**Addendum 2**
**Solicitation 26-99198**
**Hillside Sport Court, Playground & Site Improvements**

HILLSIDE SPORT COURT PARK
**ADDENDUM NUMBER 2**

This Addendum consists of 2 pages and (3) Attachments; Sheet C5.0, Sheet L-1.0 & D-1.7

Sheet Number: C5.0

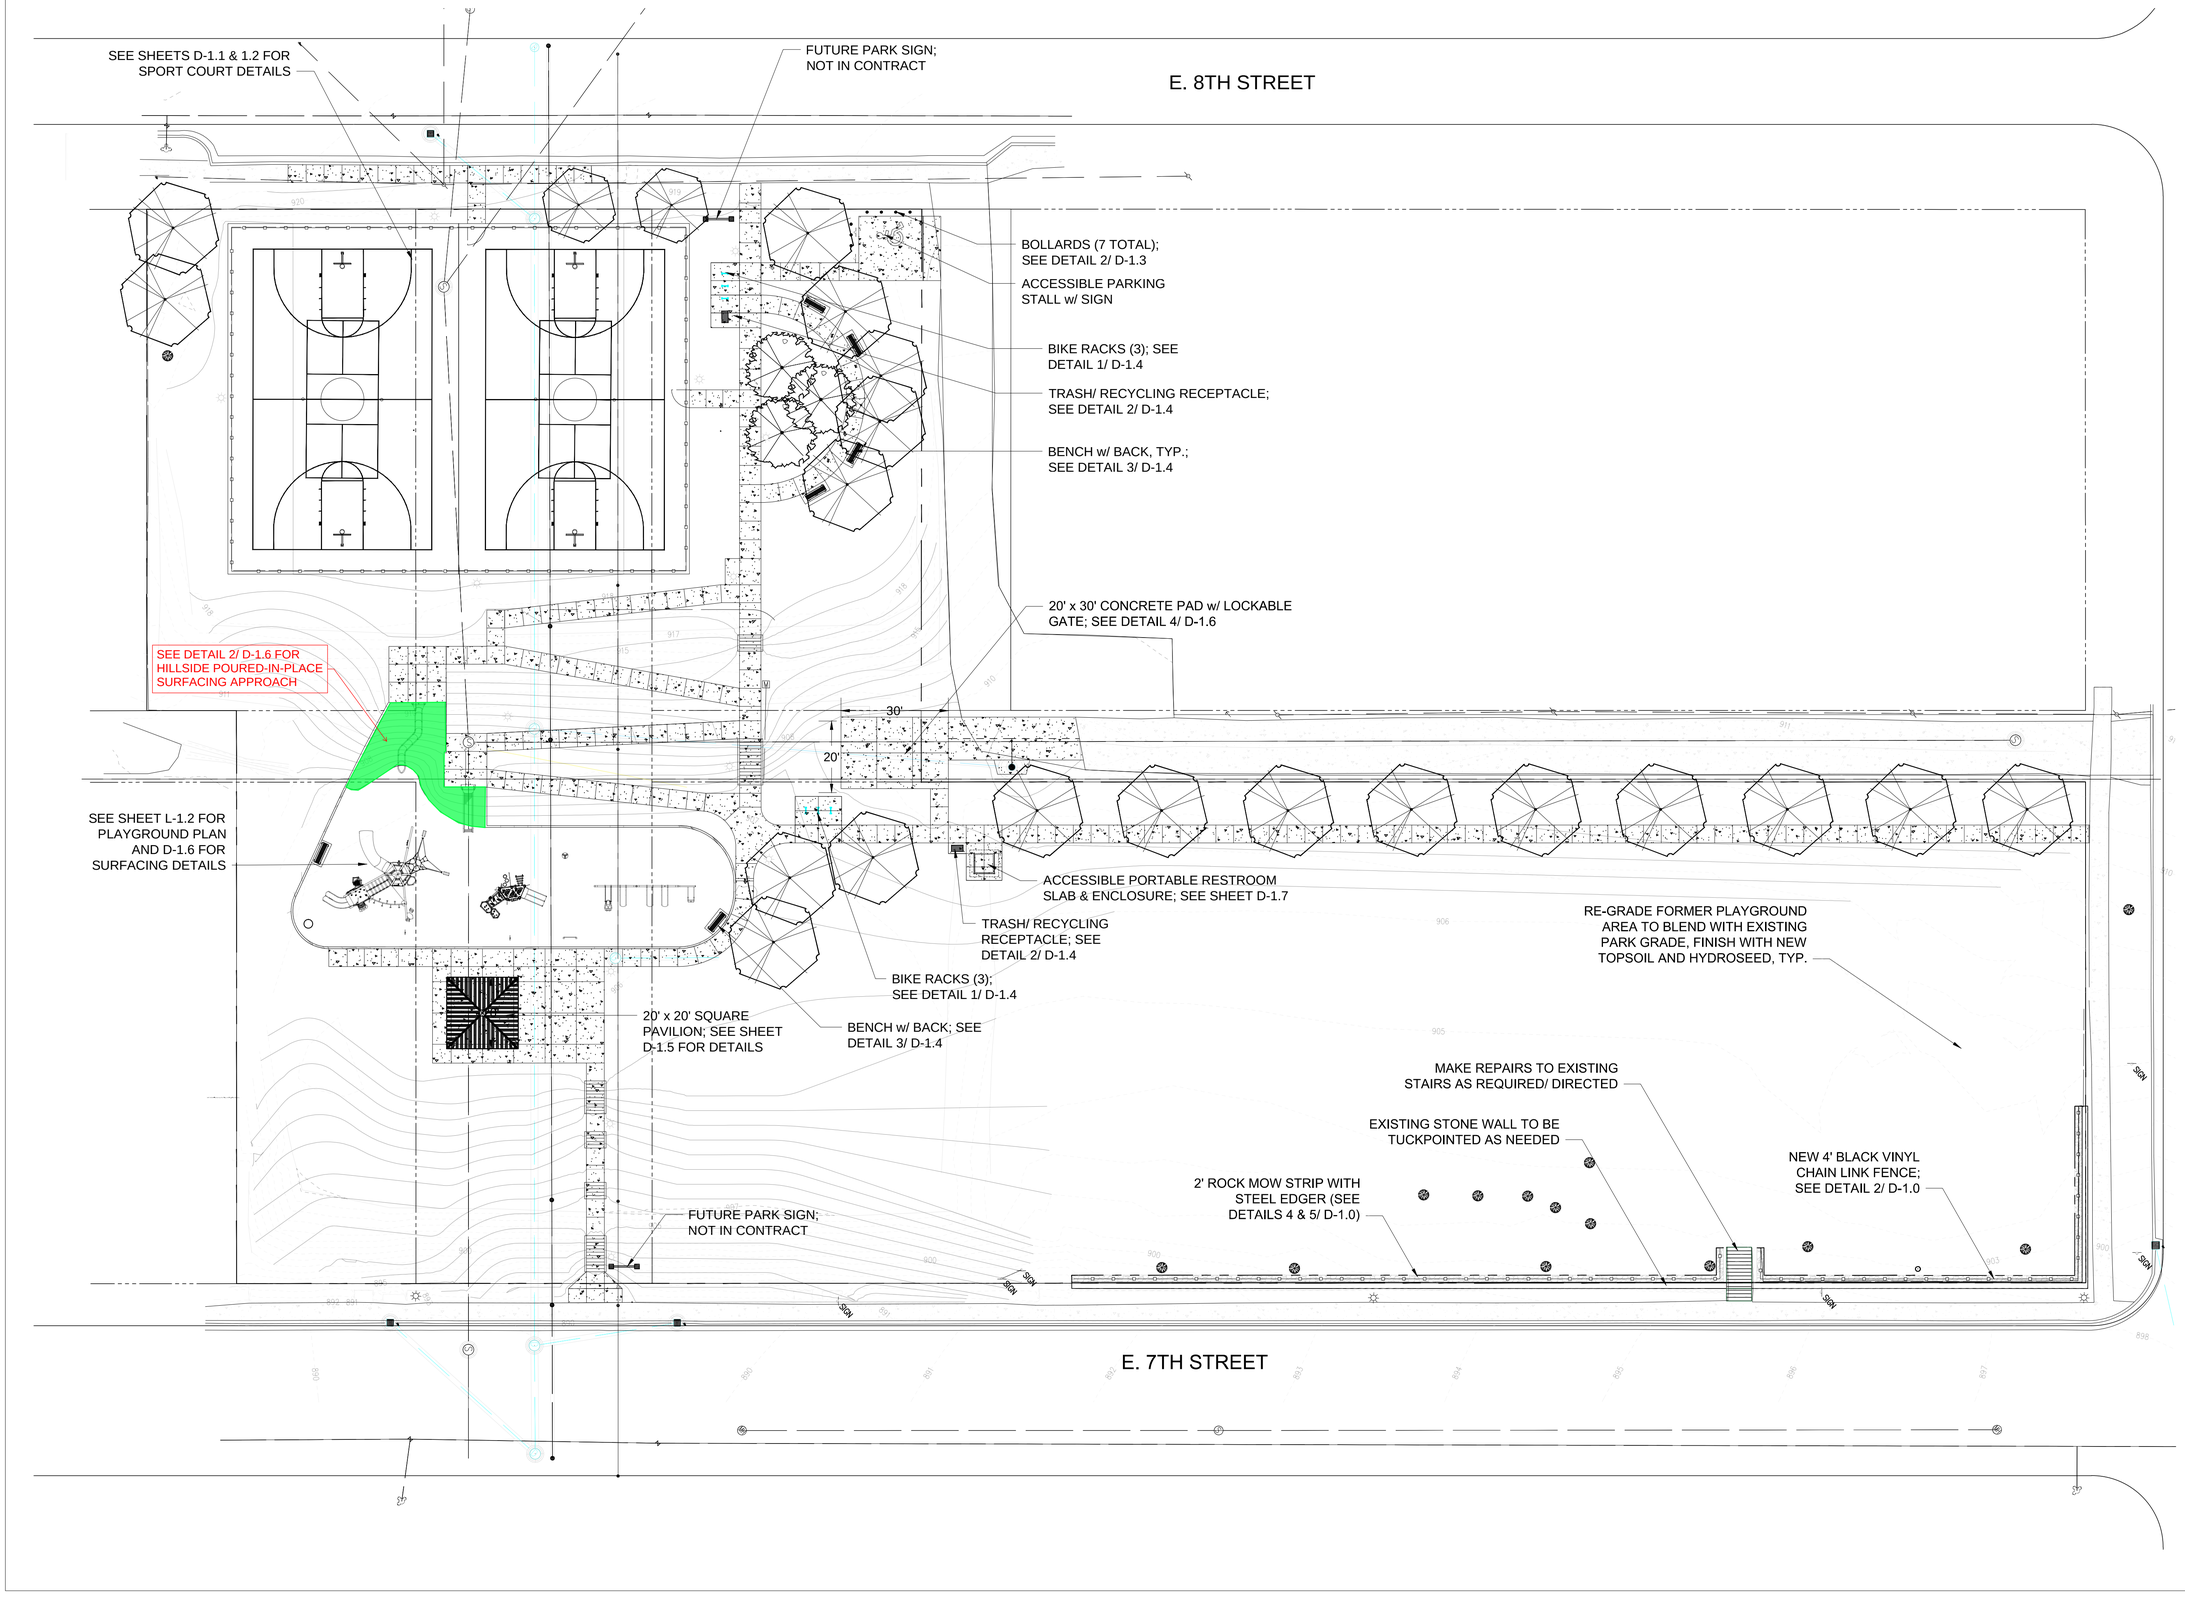
3) Fence removals and new fence location has been clarified on Civil sheet C5.0.

Sheet Number
L-1.0

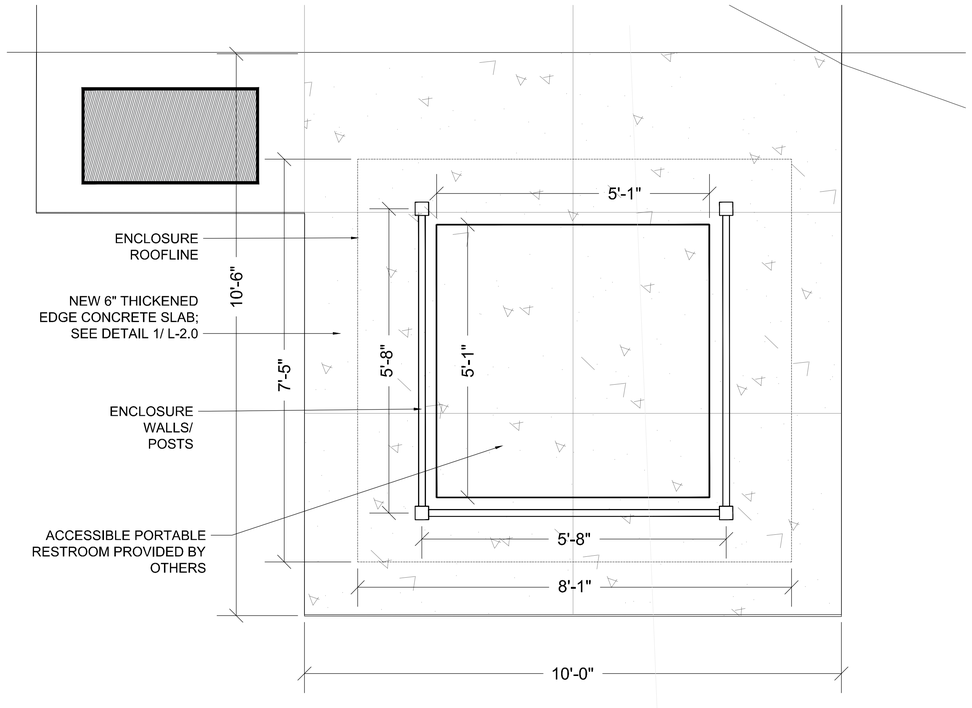
8) Question: *The detail #2 on D-1.6 is referenced to what page on the drawings?*
Response: Detail #2/ D-1.6 refers to the section of the playground underneath the slides, built into the hill (see attached sheet L-1.0 with highlighted section).

DATE: 2/18/2026
DRAWN BY: AMA
CHECKED BY: LWS
PROJECT NUMBER: 23160
SHEET NUMBER: D-1.7

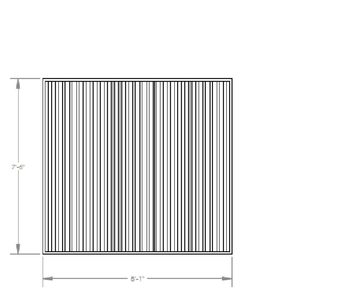
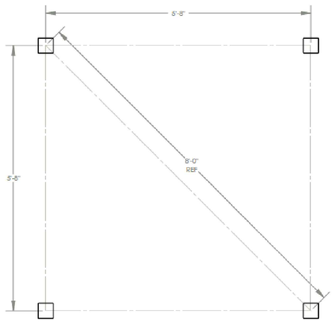
4) Addition of Bid Item #39: Portable Restroom Enclosure (plan and details on sheet D-1.7)

5) Clarification of acceptable manufacturers for Portable Restroom Enclosure on sheet D-1.7.

**Bid Item #39**
   **Portable Restroom Enclosure.** Includes providing drawings for approval, furnishing & installation of the enclosure and footings per the manufacturer's recommendation and details. Includes coordination of delivery, unloading and securing/storing on site. Also includes clean up and all related work. Measurement for payment will be on a lump sum basis.

3. ENCLOSURE TO BE MANUFACTURED BY POLIGON OR PRE-APPROVED EQUAL; MUST MEET ALL DIMENSIONS AND SPECIFICATIONS SHOWN BELOW.
